APPLICATION NO.	FILING DATE	FIRST NAMED INVENTOR	ATTORNEY DOCKET NO.	CONFIRMATION NO.
10/533,876	05/05/2005	Mats Johansson	027651-267	9663
	7590 01/15/2008 INGERSOLL & ROON	EXAMINER		
POST OFFICE BOX 1404			TRUONG, THANH K	
ALEXANDRIA, VA 22313-1404			ART UNIT	PAPER NUMBER
			3721	
•	•		NOTIFICATION DATE	DELIVERY MODE
			01/15/2008	ELECTRONIC

DETAILED ACTION

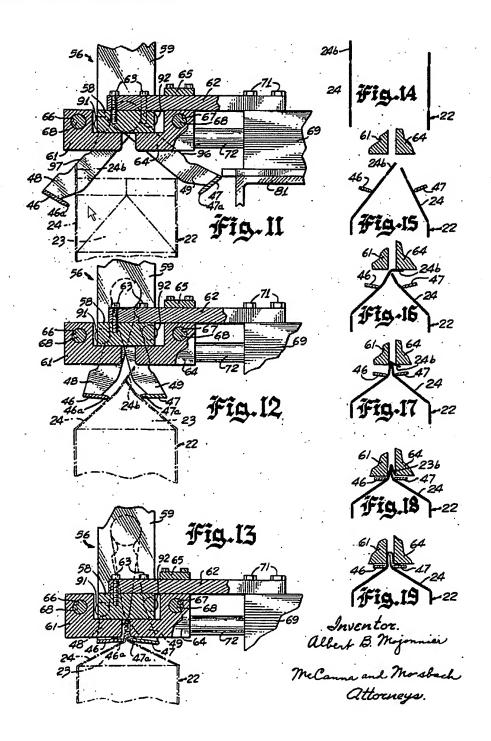
Accordingly, it is construed that, Mojonnier clearly discloses the claim as recited. The forming flap (46, 47) and the sealing halves (61, 64) are joined as partner, they are working together in a synchronization manner, they following each other in sequence to fold and seal the flap together.

Furthermore, figures 14-19 clearly anticipates claims as recited. The forming flap (24b) being <u>directly pushed</u> by the sealing member (61, 64) ... as recited (see figures 11-19 on next page).

"In this position, the closure flap 24b on the front foldable panel of the carton is engaged by the rear movable jaw 64 of the sealing mechanism and the latter deflects the foldable portion downwardly, as best shown in Fig. 16 ... the position shown in Fig. 13 moves both of the folding bars 46 and 47 towards each other to firmly press the foldable panels 24 of the cartons together. At this point, the sealing mechanism is operated to move the rear jaw 64 forwardly to compress the foldable panels and closure flap together and seal the carton as diagrammatically shown in Fig. 19." (emphasis added) (column 5, lines 38-58).
